**Changed Pages**

**Landfill Gas Management Plan Figures**

**Pescadito Environmental Resource Center  
MSW No. 2374  
Webb County, Texas**

Initial Submittal March 2015  
Revised September 2015  
Technically Complete March 11, 2016  
Modified October 2016  
**Modified August 2017**

**LANDFILL GAS MONITORING PLAN**

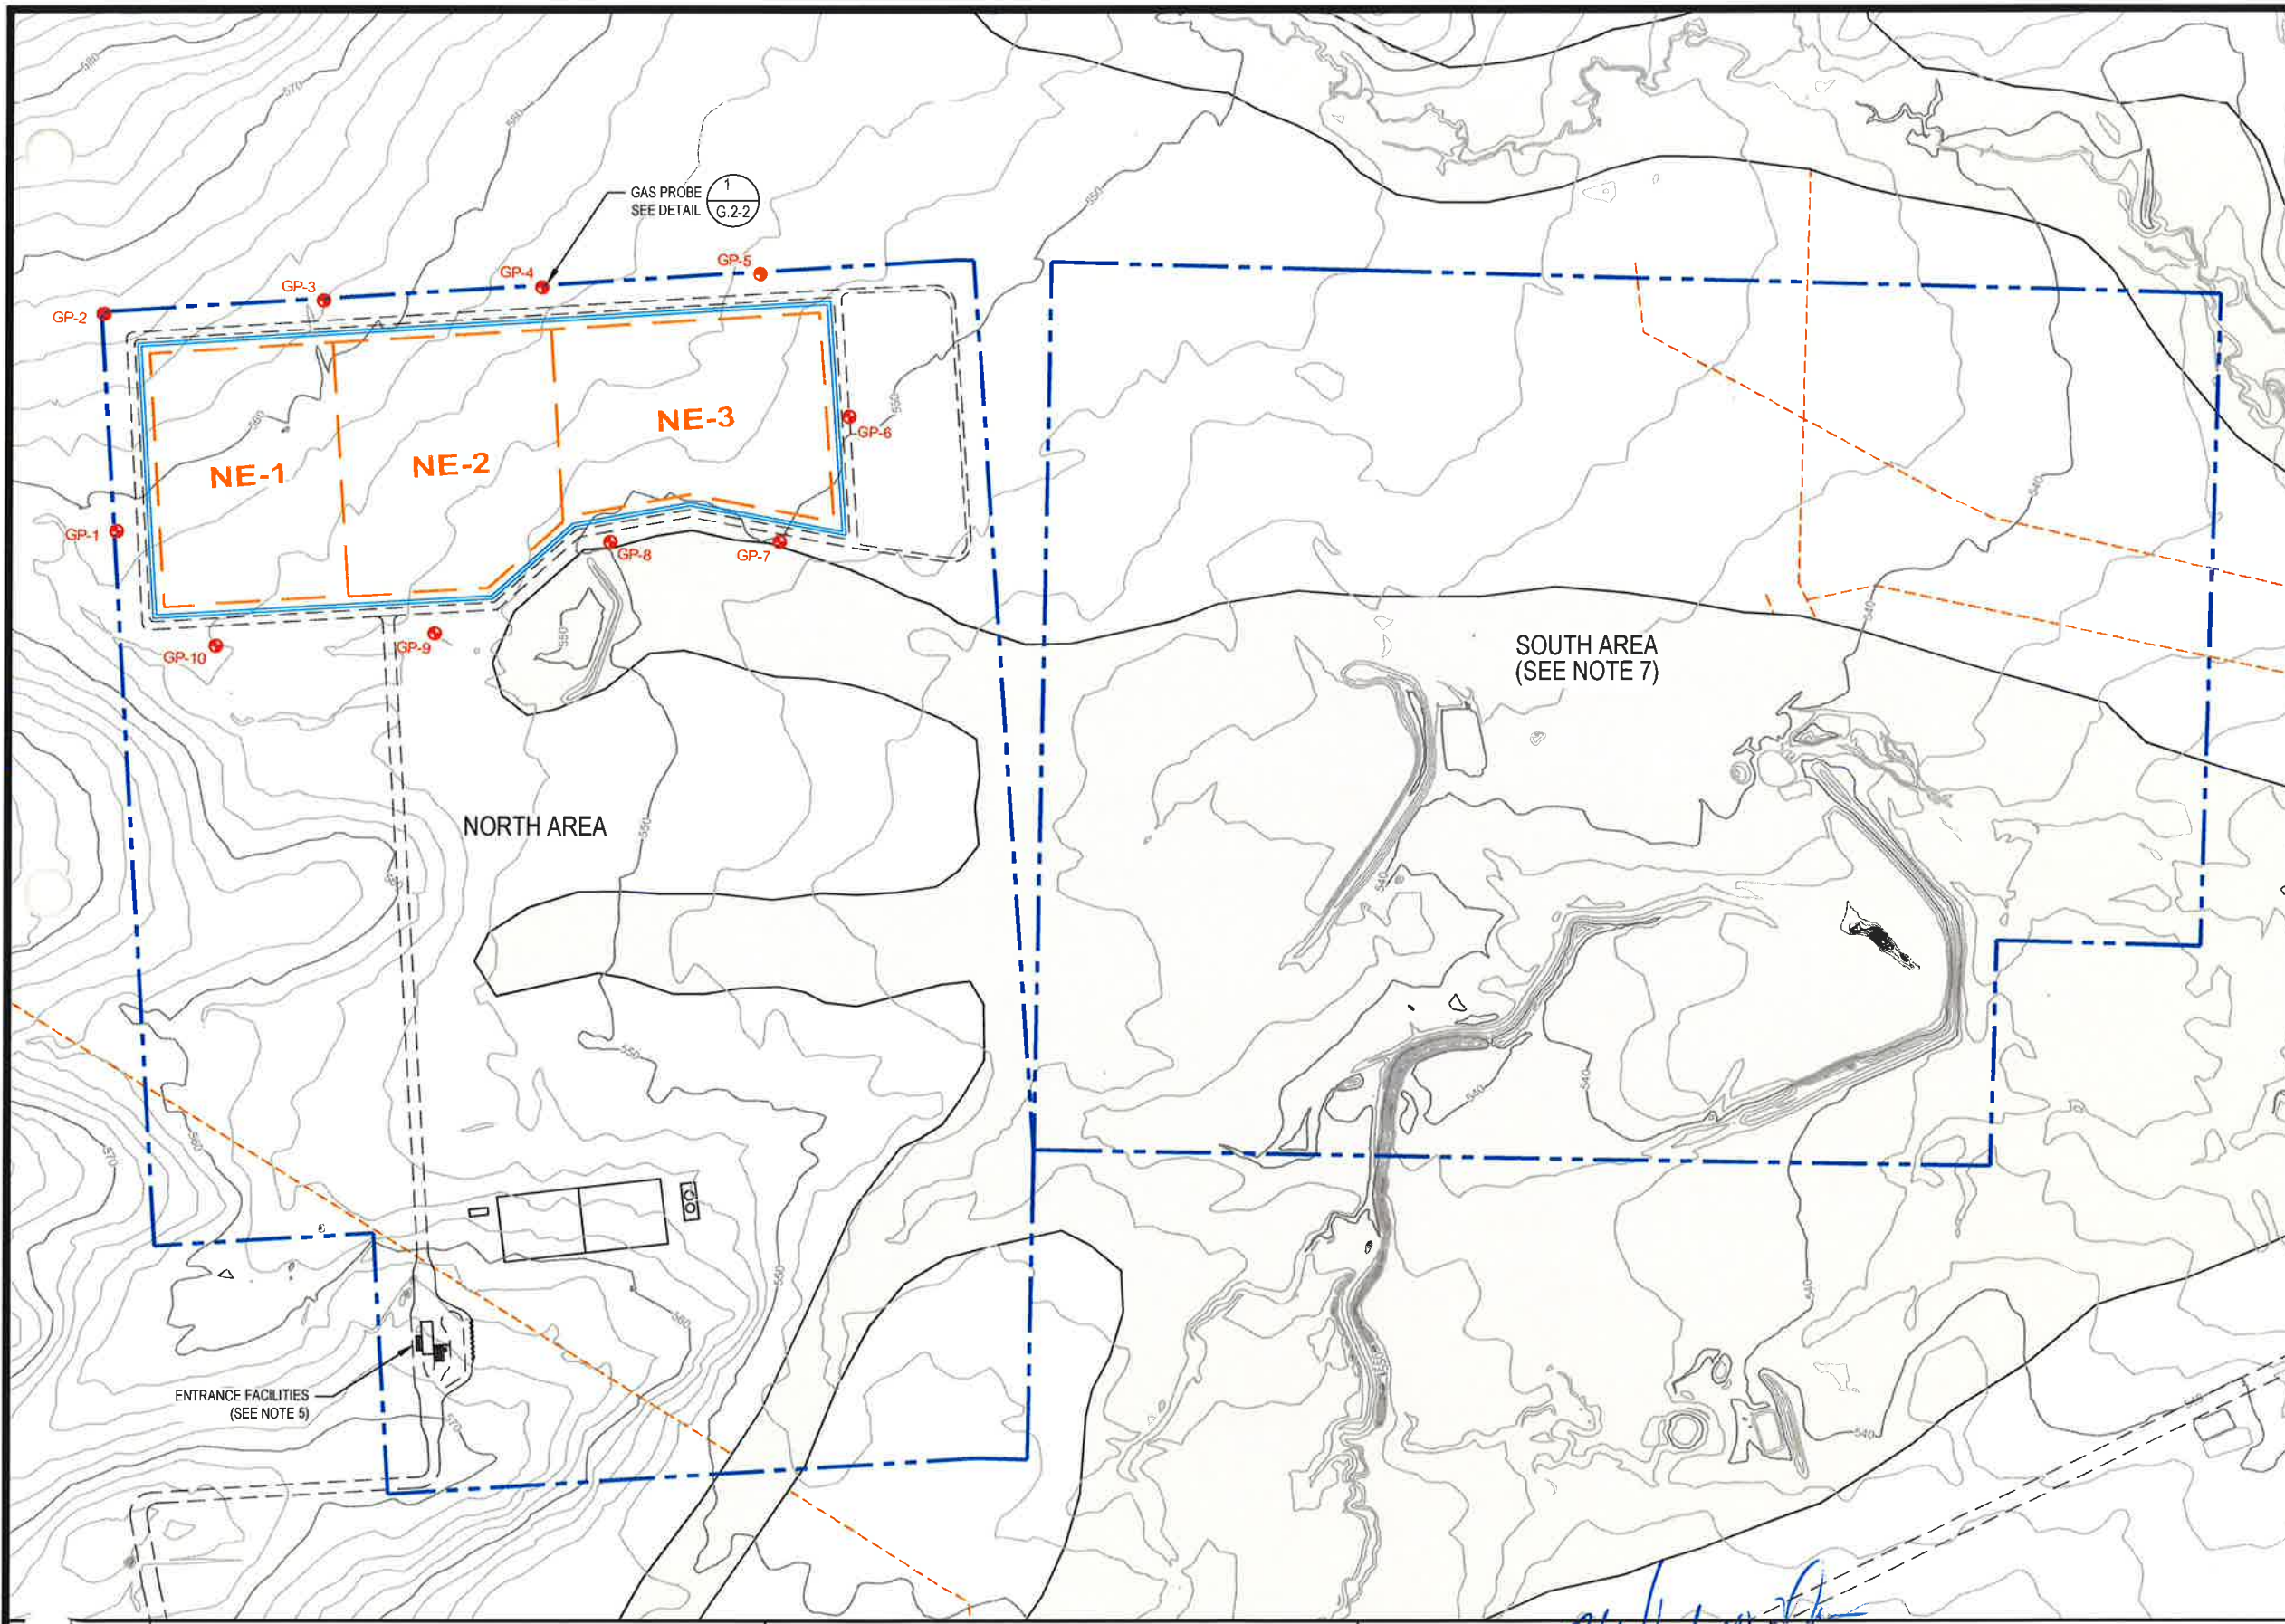
REV. NO.	DATE	DESCRIPTION
2	08/2017	REVISED WASTE UNIT BOUNDARY AND PROBE LOCATIONS
1	10/2016	ADDED CELL LAYOUT AND INSTALLATION SCHEDULE

TYPICAL GAS PROBE

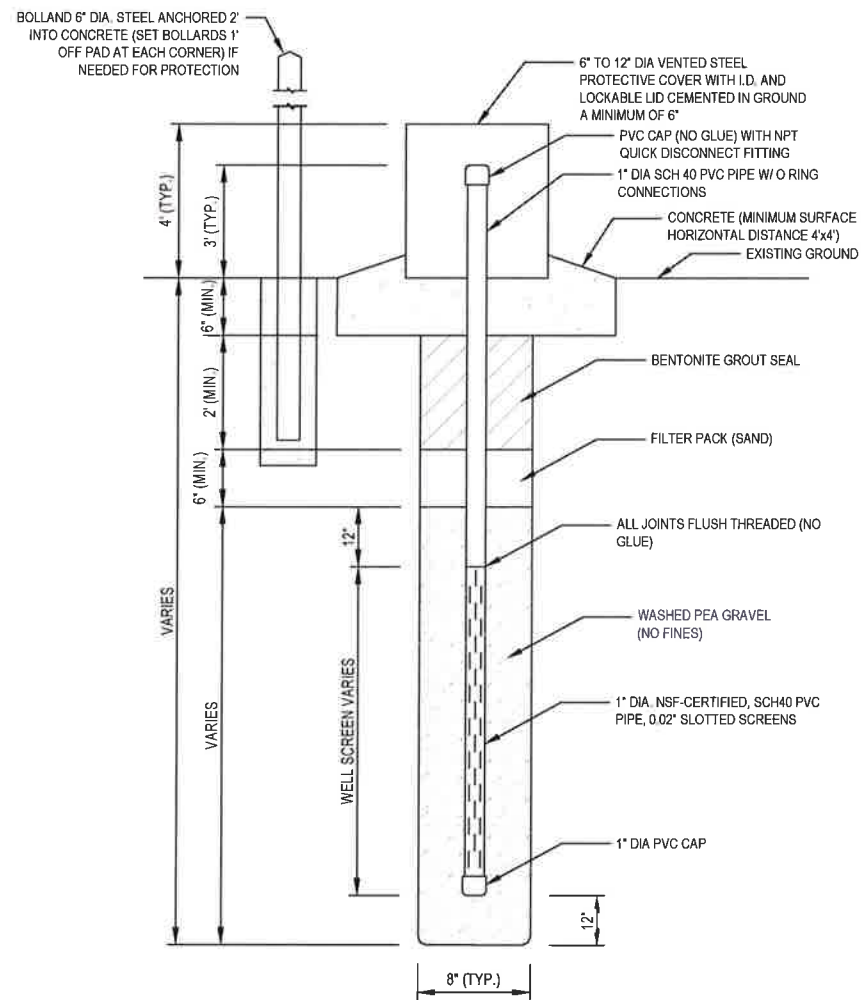
REV. NO.	DATE	DESCRIPTION
2	08/2017	UPDATED SCHEDULE, REMOVED VENT
1	09/2015	NOD 1
